APRIL 24 1979

The Commission has issued the enclosed Amendments Nos. 38 and 21 to Facility Operating Licenses Nos. DPR-53 and DPR-69 for the Calvert Cliffs Nuclear Power Plant, Units Nos. 1 & 2 (CCNPP-1/2). The amendments consist of changes to the Appendix A and B Technical Specifications (TS) in response to your applications dated November 13, 1978 and January 31, 1979.

CALVERT CLIFFS NUCLEAR POWER PLANT, UNIT NO. 1

Amendment No. 38  
License No. DPR-53

**FIGURE 3.1-1**  
**Minimum Boric Acid Storage Tank Volume and Temperature**  
**as a Function of Stored Boric Acid Concentration**

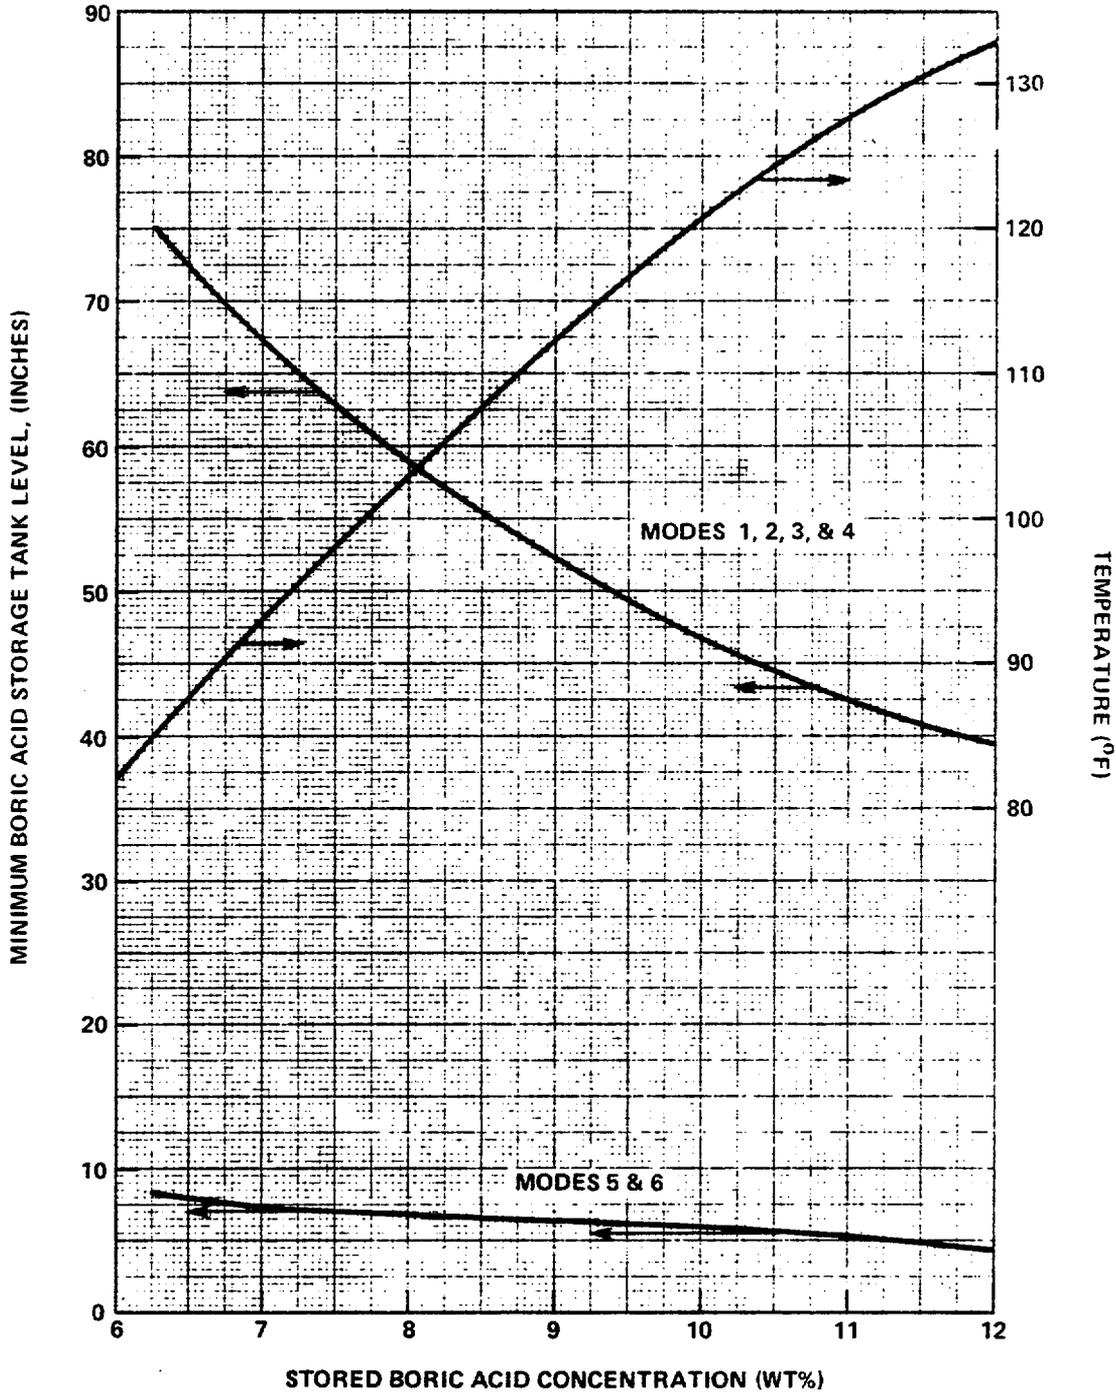
- a. Two boric acid storage tank(s) and one associated heat tracing circuit per tank with the contents of the tanks in accordance with Figure 3.1-1 and the boron concentration limited to  $\leq 8\%$ , and
- b. The refueling water tank with:
  1. A minimum contained borated water volume of 400,000 gallons,
  2. A boron concentration of between 1720 and 2200 ppm,
  3. A minimum solution temperature of 40°F, and
  4. A maximum solution temperature of 100°F in MODE 1.

FIGURE 6.2-1  
 Management Organization Chart  
 Calvert Cliffs Nuclear Power Plant  
 Baltimore Gas & Electric Company

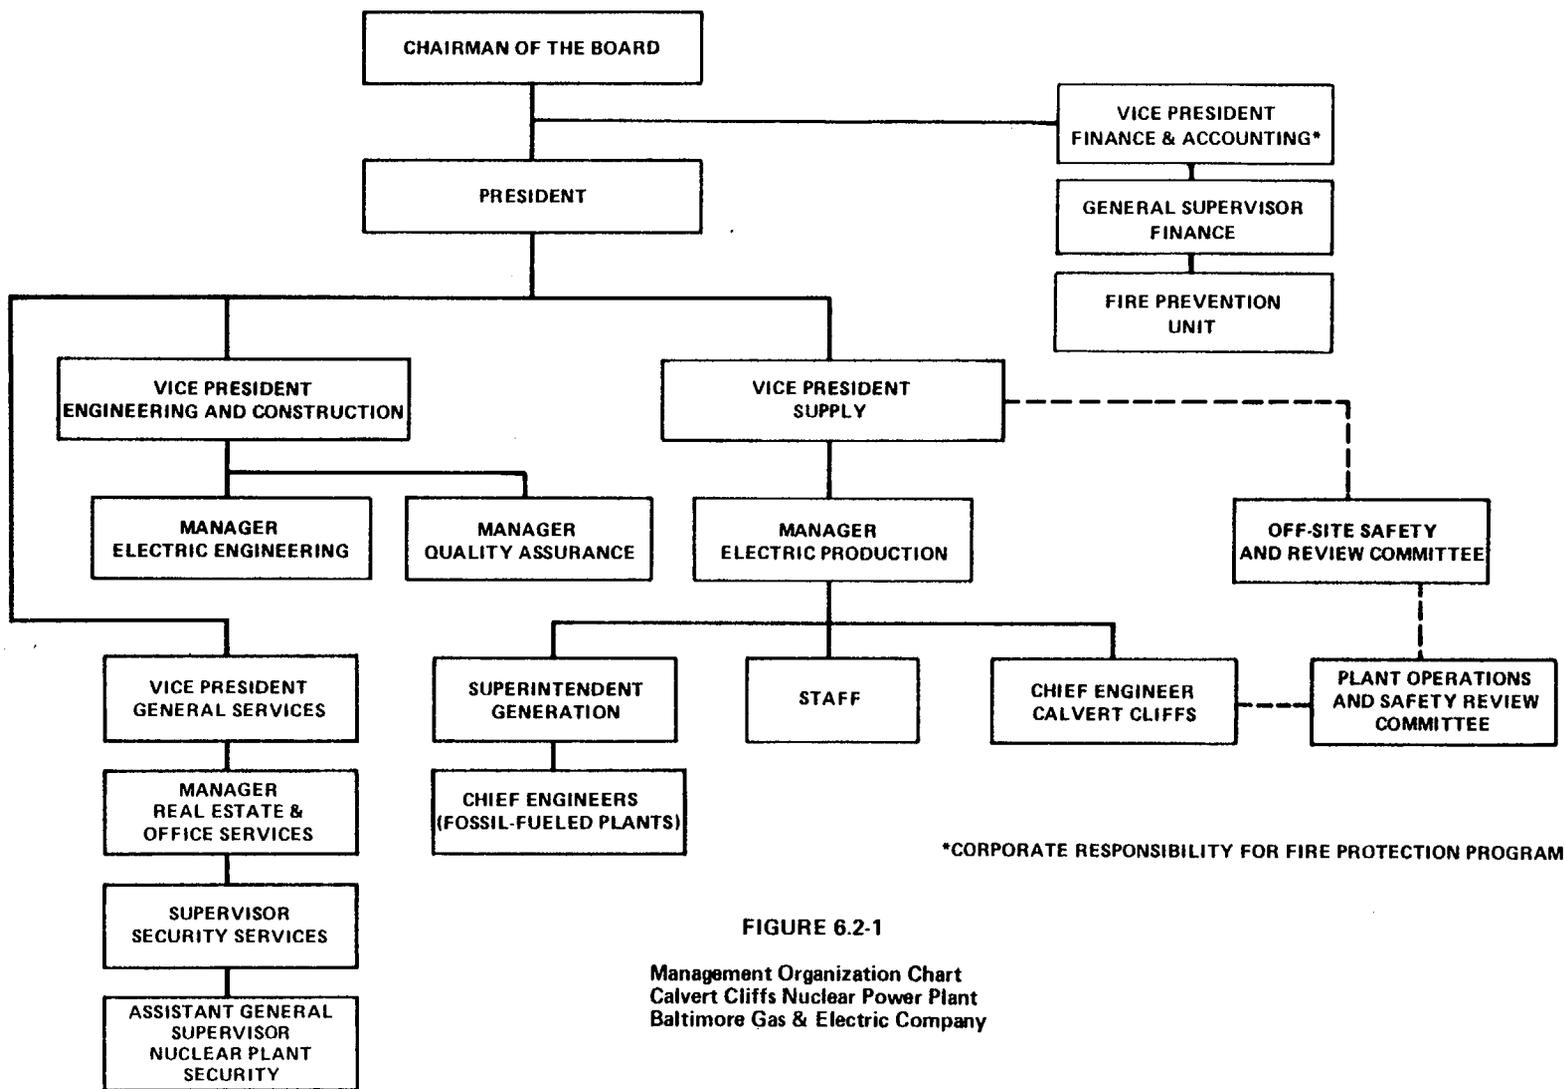
BG&E has recently placed the CCNPP security force under the cognizance of the Real Estate and Office Services Department. This is consistent with other BG&E security functions. Proposed change No. 10 of the November 13, 1978 letter reflects this organizational modification. The proposed title of one of the positions needs to be modified to agree with the title documented by the BG&E security submittal. BG&E has agreed to this change in title.

We find this change continues to provide adequate separation between the security organization and the plant operating staff. Therefore, we conclude that the proposed change in security force organization is acceptable.

**FIGURE 3.1-1**  
**Minimum Boric Acid Storage Tank Volume and Temperature**  
**as a Function of Stored Boric Acid Concentration**

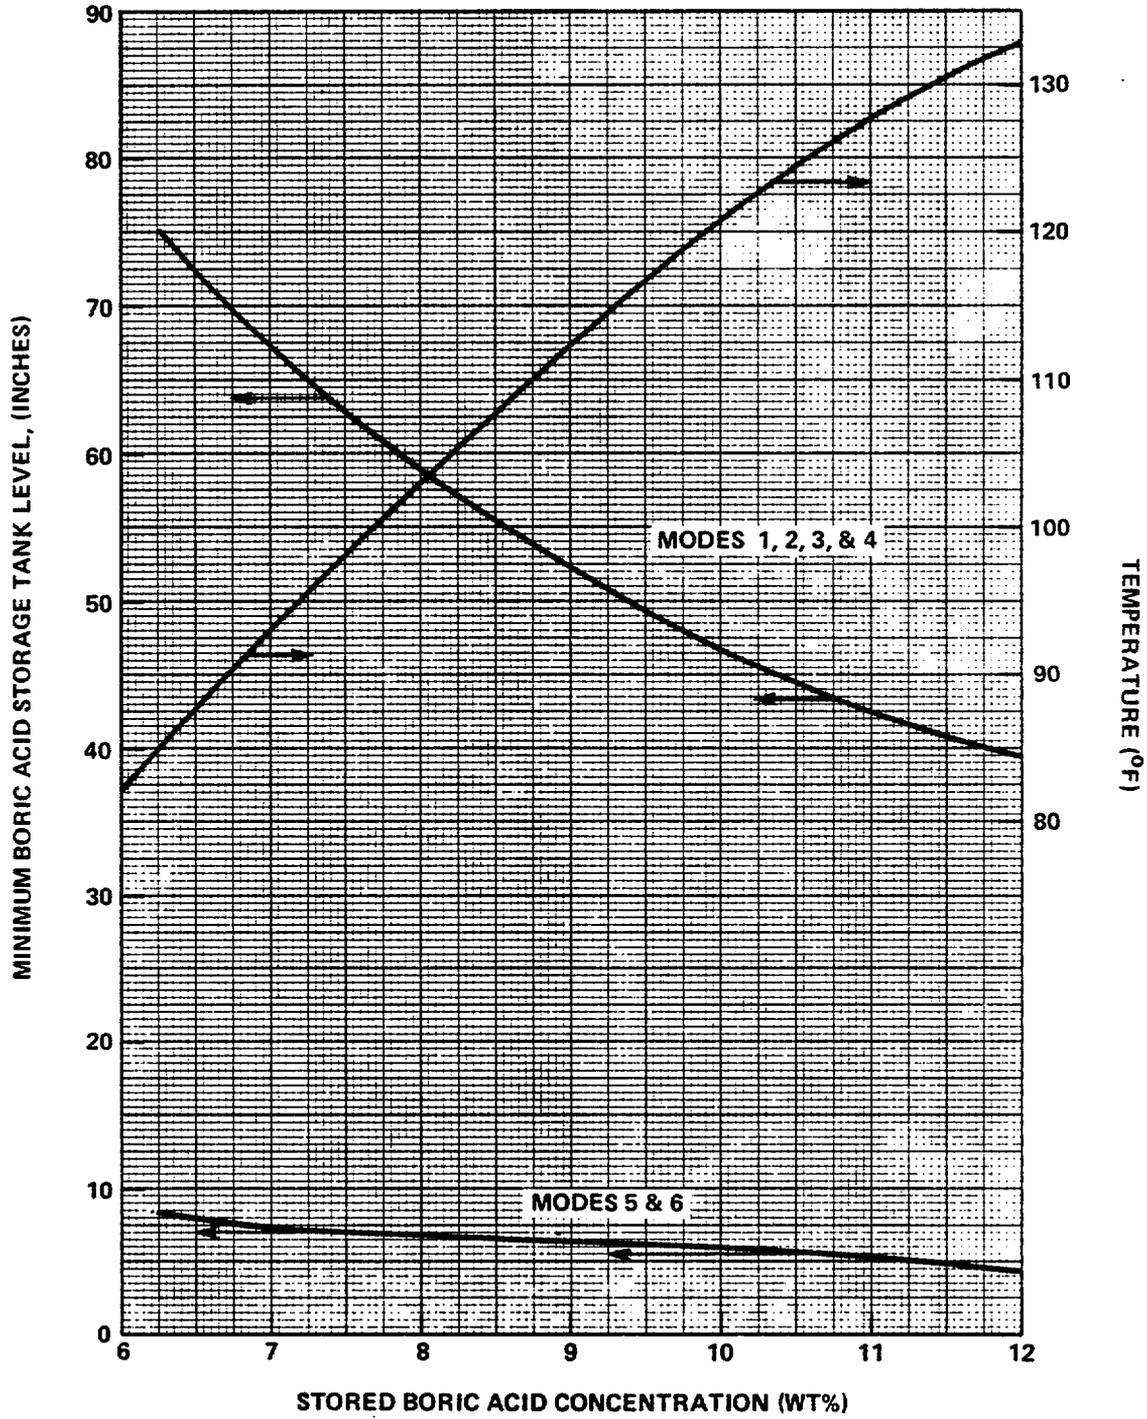
- a. Two boric acid storage tank(s) and one associated heat tracing circuit per tank with the contents of the tanks in accordance with Figure 3.1-1 and the boron concentration limited to  $\leq 8\%$ , and
- b. The refueling water tank with:
  1. A minimum contained borated water volume of 400,000 gallons,
  2. A boron concentration of between 1720 and 2200 ppm,
  3. A minimum solution temperature of 40°F, and
  4. A maximum solution temperature of 100°F in MODE 1.
